UNITED STATES
DEPARTMENT OF THE INTERIOR
BUREAU OF LAND MANAGEMENT

SUNDRY NOTICES AND REPORTS ON WELLS
Do not use this form for proposals to drill or to re-enter an abandoned well. Use form 3160-3 (APD) for such proposals.

1. Type of Well <input checked="" type="checkbox"/> Oil Well <input type="checkbox"/> Gas Well <input type="checkbox"/> Other	8. Well Name and No. TODD 13B FED 2
2. Name of Operator DEVON ENERGY PRODUCTION COMPANY Contact: MAX LUBITZ Email: max.lubitiz@dvn.com	9. API Well No. 30-015-28904-00-S1
3a. Address 333 WEST SHERIDAN AVENUE OKLAHOMA, OK 73102	10. Field and Pool or Exploratory Area INGLE WELLS
3b. Phone No. (include area code) Ph: 580-302-4593	11. County or Parish, State EDDY COUNTY, NM
4. Location of Well (Footage, Sec., T., R., M., or Survey Description) Sec 13 T23S R31E NWNE 990FNL 1930FEL

Permanent Abandonment of Federal Wells
Conditions of Approval (LPC Habitat)

Well Name: Todd 13B Federal #2		Field: Ingle Wells (Delaware)	
Location: Sec 13-T23S-R31E; 990' FNL & 1930' FEL		County: Eddy	State: NM
Elevation: 3498' GL		Spud Date: 3/12/97	Compl Date: 5/15/97
API#: 30-015-28904	Prepared by: Ronnie Slack	Date: 10/18/05	Rev:

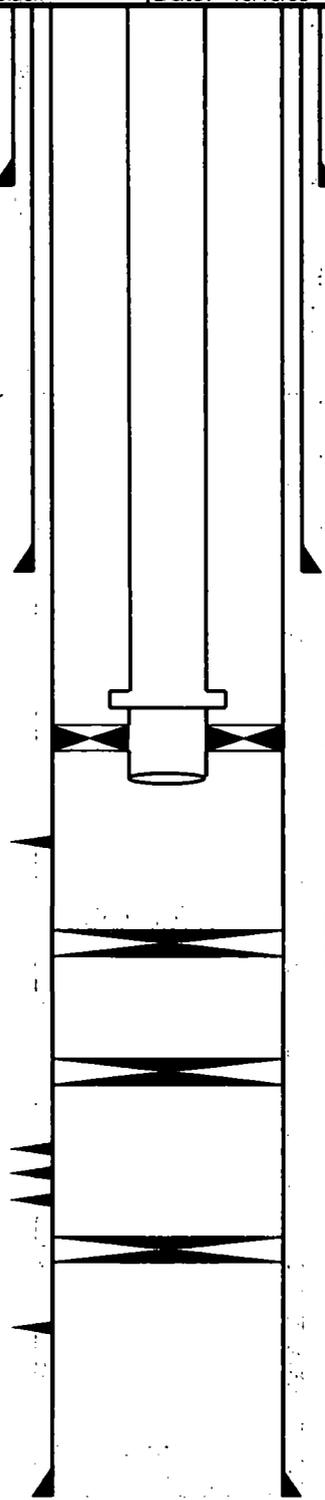
1. MIRU P&A unit.
2. Pull packer @ 5735 and 2-7/8" injection tubing.
3. Set CIBP @ 5,700'. Circulate w/10# salt gel mud.
4. Spot 20 sx, CI C cmt on top to 5600'. (Open Delaware Perfs at 5760') *25 sx min.*
5. Spot 120 sx, CI C cmt to 4300-3400'. WOC & tag. (Top of Delaware, 4441', Shoe 4364', B. Salt ~~447~~ 4547 - 4205)
6. Perf @ 3350' Pump 300 sx, CI C cmt 3350-1150'. WOC & tag. (T. Salt 1147' R-444P) *Perf @ 1197, 502 cmt to 844*
7. Perf @ 950' Pump 25 sx, CI C cmt 950-850'. WOC & tag. (Shoe 894') *woc Tag (Salt & Shoe)*
8. Perf @ 140'. Pump 35 sx CI C in/out to surface.
9. Cut wellhead off 3' BGL. Set dry hole marker. *Below ground level dry hole marker required.*
10. (well inside R-444P boundary. Salt section noted @ 1,147' - 4,208')
Secretary's Potash Only
GC 12-3-18
Accepted for record - NMOCD

Well Name: Todd 13B Federal #2		Field: Ingle Wells (Delaware)	
Location: Sec 13-T23S-R31E; 990' FNL & 1930' FEL		County: Eddy	State: NM
Elevation: 3498' GL		Spud Date: 3/12/97	Compl Date: 5/15/97
API#: 30-015-28904	Prepared by: Ronnie Slack	Date: 10/18/05	Rev:

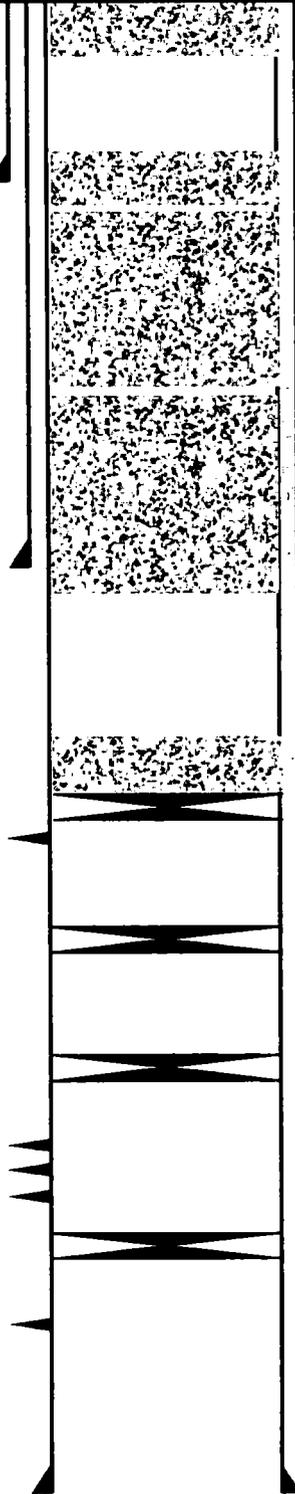
Proposed:
1) Perf @ 140'
2) Pump 25 sx, CI C cmt 140-surface
3) Cut off 3' below surface. Instal DHM.

Proposed:
1) Perf @ 950'
2) Pump 25 sx, CI C cmt 950-850'. WOC & tag. (Shoe 894')

Proposed:
1) Perf @ 3350.
2) Pump 300 sx, CI C cmt 3350-1150'. WOC & tag. (T. Salt 1147' R-111P)

Proposed:
1) Spot 120 sx, CI C cmt to 4300'-3400'. WOC & tag. (Top of Delaware, 4441', Shoe 4364', B. Salt 4208-R-111P)

Proposed:
1) Set CIBP @ 5700'
2) Spot 20 sx, CI C cmt on top to 5600'. (Open Delaware Perfs at 5760')
